CITY OF
JOHN DAY

CITY COUNCIL MEETING AGENDA

8. Public Hearing: (file# SDR 24-01)
   The Oregon State Parks and Recreation Department (OPRD) is requesting Site Design Review for the new construction of the Kam Wah Chung State Heritage Site and Interpretive Center. OPRD also requests the vacation of two historic easements on the site; a historic setback and a waterline easement that is no longer needed. This application is being elevated to a type IV land use review. The Planning Commission recommended approval with conditions:

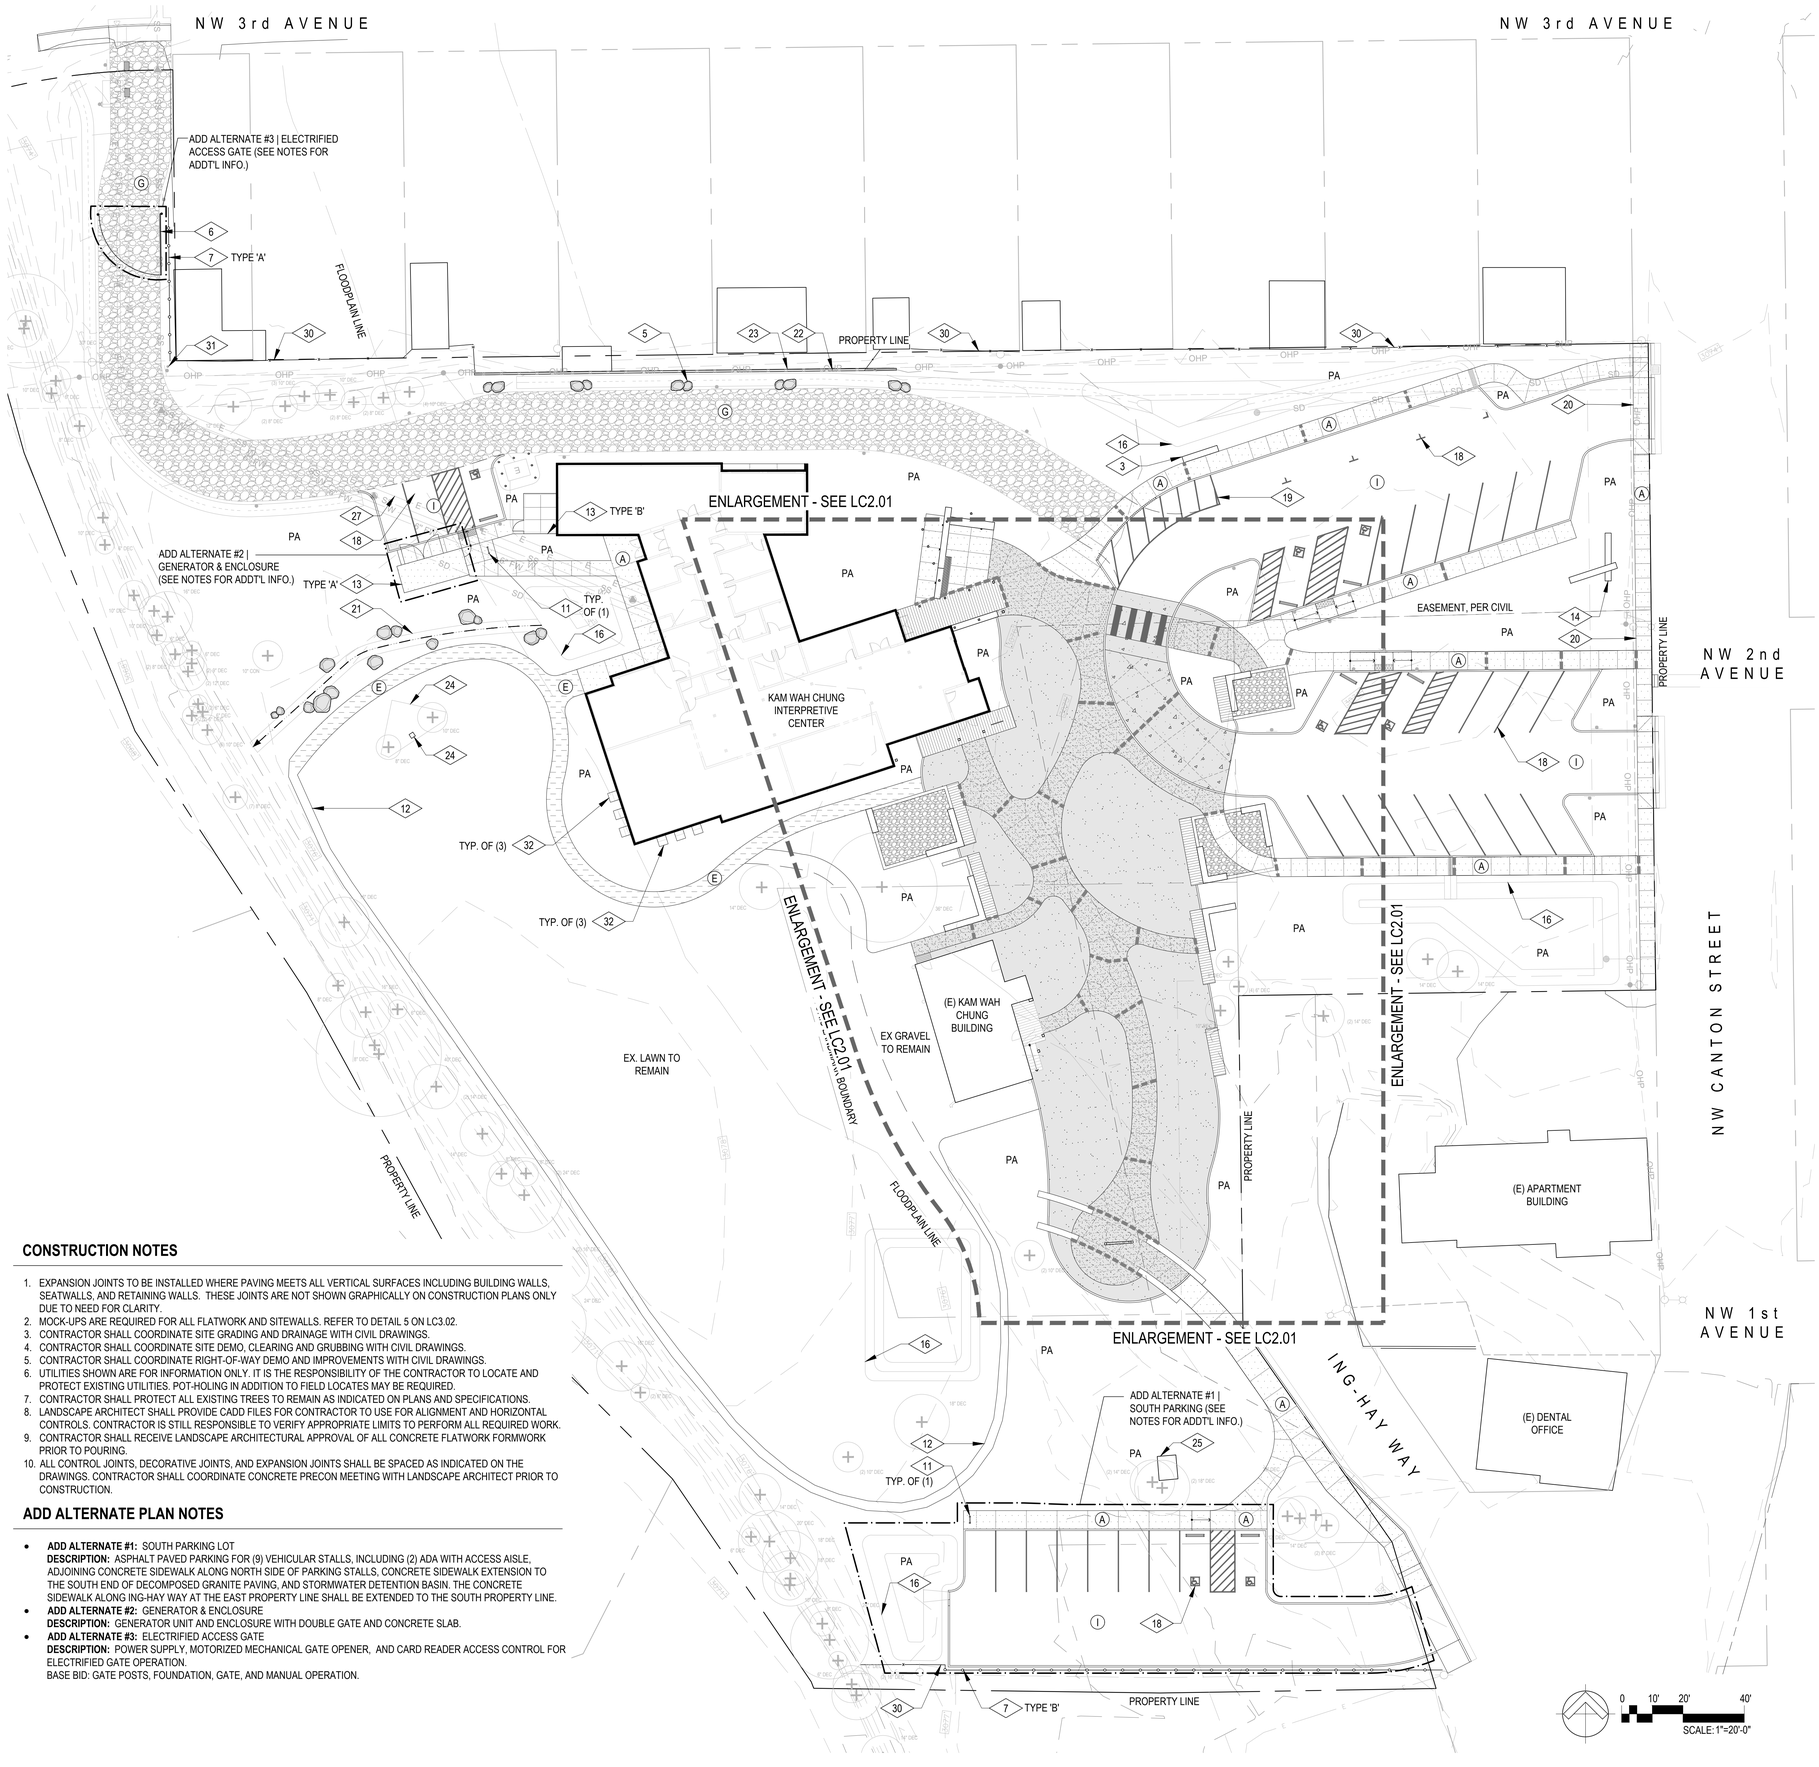
Staff Response: The applicant submitted a Landscape and Construction Plan, shown on Sheets LC1.01 and LP6.01 (**Exhibit A**). The landscape plan includes pedestrian paving for internal paths, a City multi-use pedestrian path (as adopted in the Local Street Network Plan), identification of trees to remain, and the introduction of new vegetation—including broad-canopy deciduous trees, small accent trees, screening shrubs, and ornamental grasses and perennials such as feather red grass, Great Basin wildrye, white yucca, and various ground cover plantings. The landscape plans are sufficient for staff-level review and meet the applicable standards outlined above.

Staff Response: As shown on Sheet LC1.01, a 20-foot wide fire lane is provided at the northern end of the site. This fire lane offers separate and controlled access to the site via 3rd Avenue and will include a lock box or gate. Its use is restricted to employee access and parking only, and by emergency personnel.

Staff Response: As seen on Sheet LC1.01, a continuous pedestrian walkway system is provided throughout the site.

Staff Response: As shown on Sheet LC1.01, the entire site features a safe, direct, and convenient pedestrian network. This network connects parking areas and other walking spaces directly to the Center's primary entrance. Criterion met. Stripped contrasting pavement is also included to delineate the pedestrian path from the parking lot to the sidewalk leading into the Center's main entrance. Refer to Sheet LC1.01 for details.

Staff Response: Trees to remain are denoted on the landscape plans with a (+). Refer to Sheets LC1.01 through LP7.01.

1 ENTRY MONUMENT SIGNAGE
SCALE: 1/2"= 1'-0"

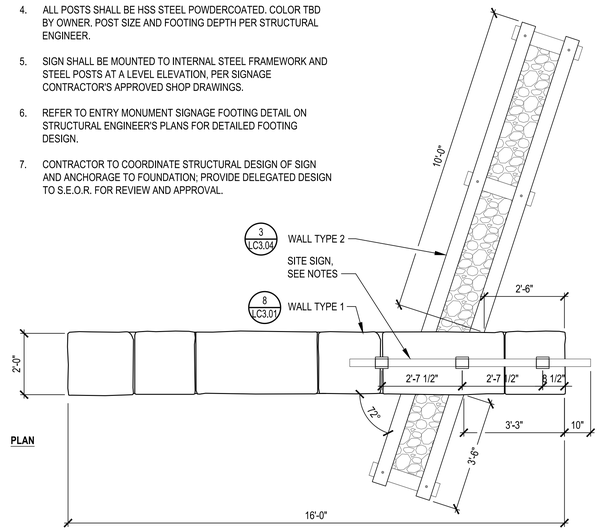
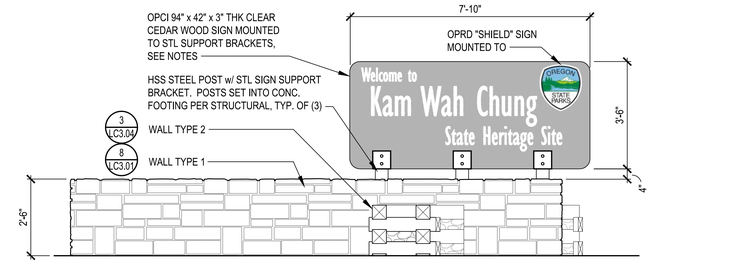
Staff Response: An entry sign is proposed and is provided below and can be found on Sheet LC3.03. The following conditions apply to signs in all zones:

Judging by the site plans, the proposed sign meets all of the conditions above. Condition D is not applicable. Applicant is advised that final placement and construction of the sign seen on Sheet LC3.03 and any other signs proposed shall conform to the adopted standards as contained in Chapter 5-3.5.010, General Sign Standards in All Zoning Districts. Criterion met.

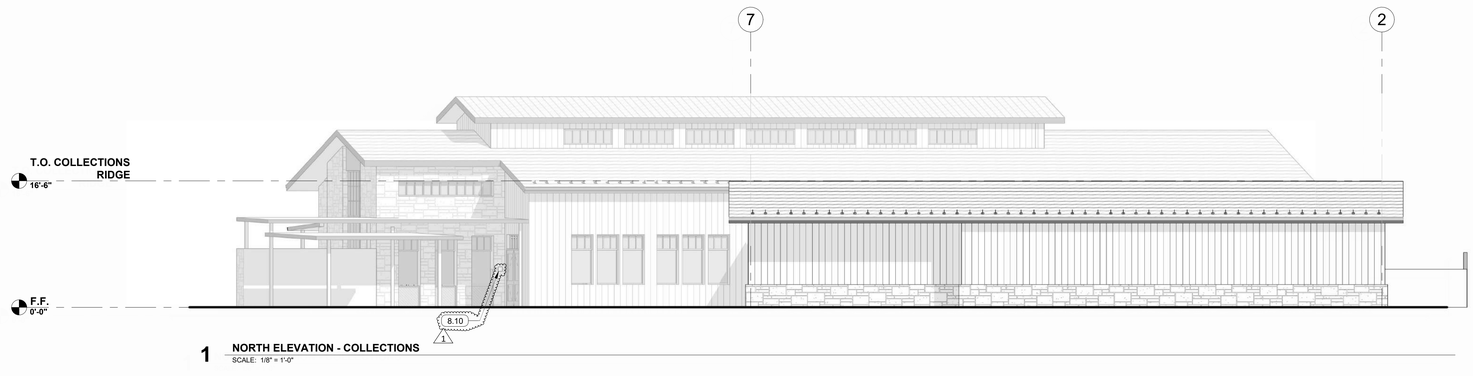
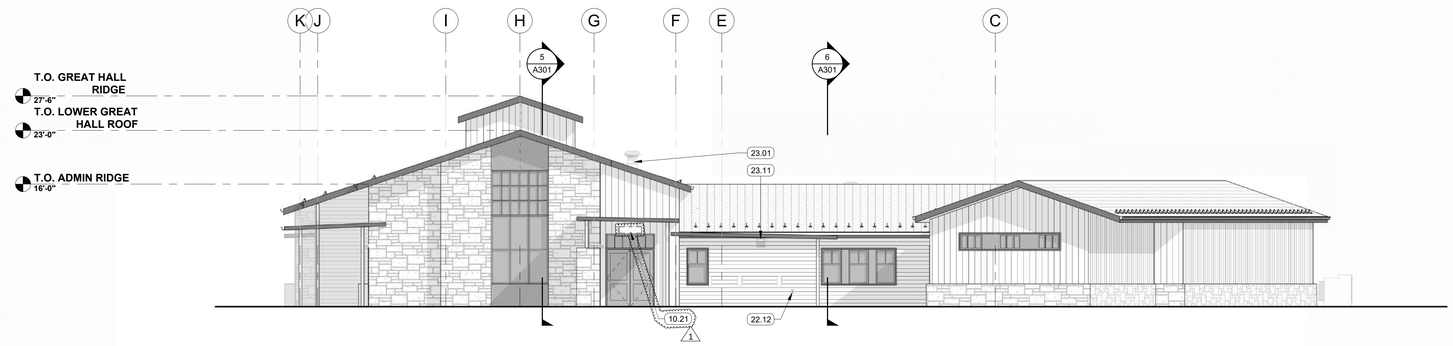
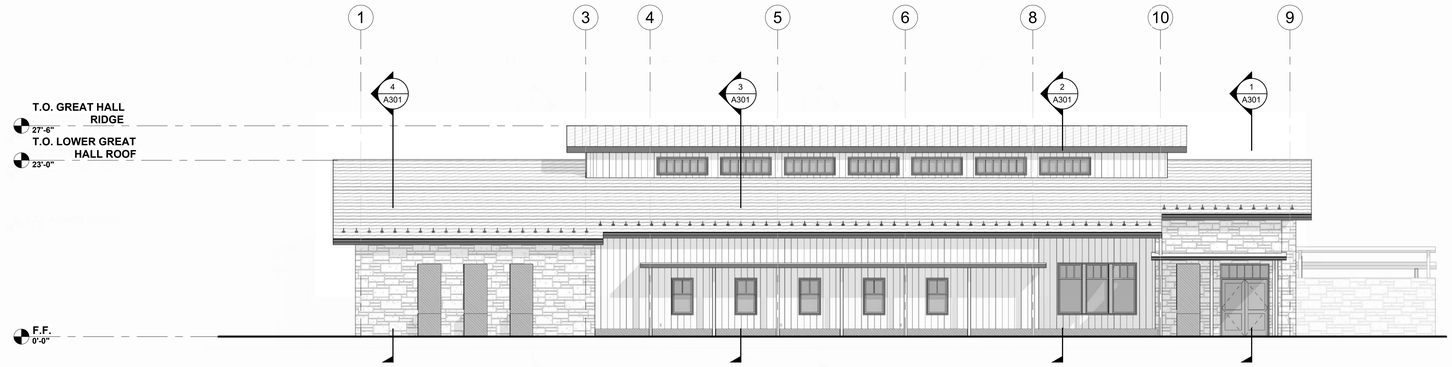
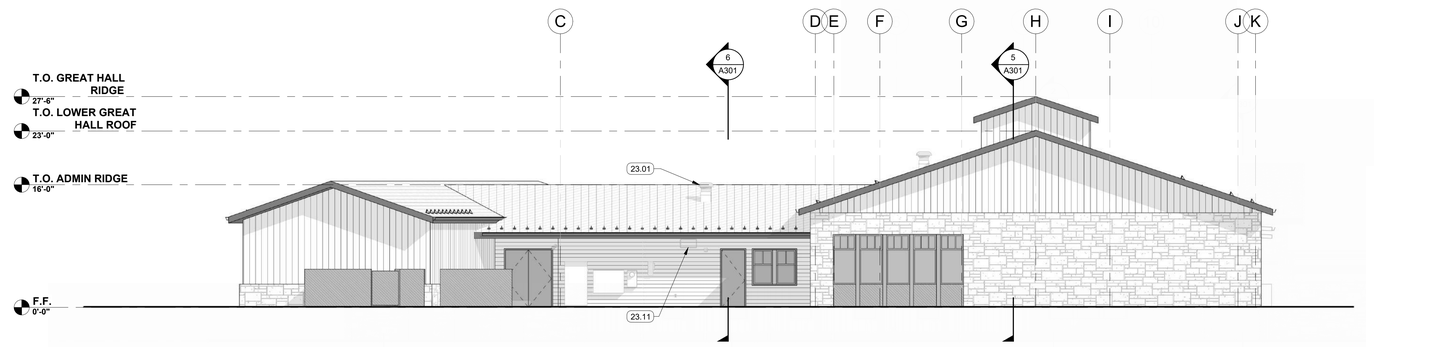
Staff Response: Exterior elevations are shown on Sheet A201 (Elevations are included in **Exhibit A**). Building materials include vertical wood siding, horizontal lap siding, coursed ashlar stone, a standing seam metal roof, trim, and fascia. The maximum height of the new building is 27 feet, 6 inches. The architectural firm designing the building is Cole Architects.

Exhibit 3 – Shared Use Path Dimension

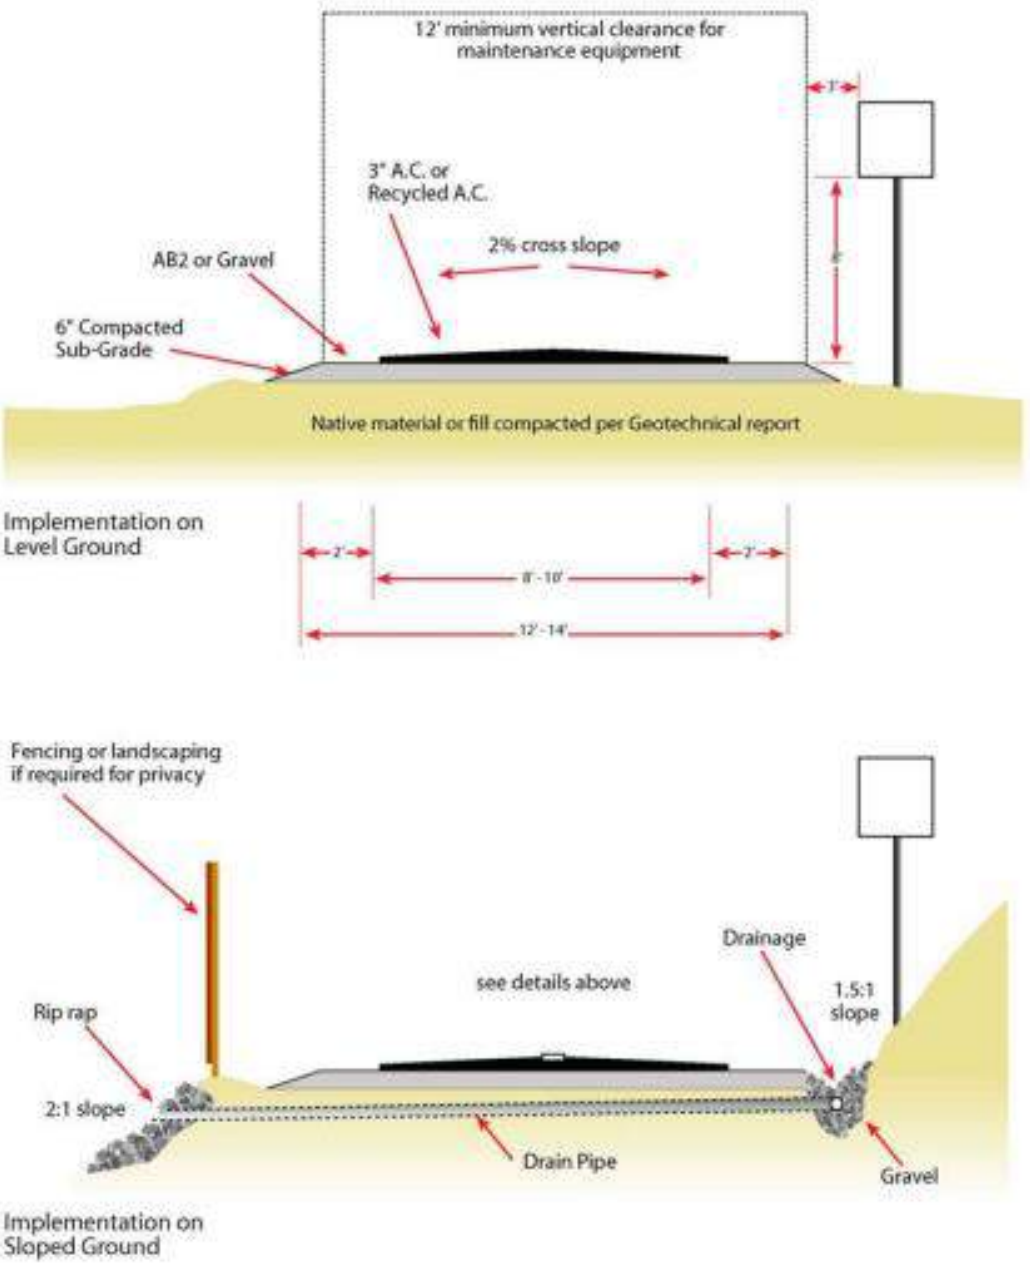
The multi-use path shall be constructed in accordance with the standards shown in *Exhibit 3 – Shared Use Path Dimensions*, as outlined in the John Day Transportation System Plan. Recognizing that the path has not yet been designed and that construction is likely several years away, modifications to

Exhibit 3 may be authorized in writing by the John Day Planning Commission—upon the advisement of the City Engineer—to accommodate terrain, floodplain constraints, or other engineering challenges.
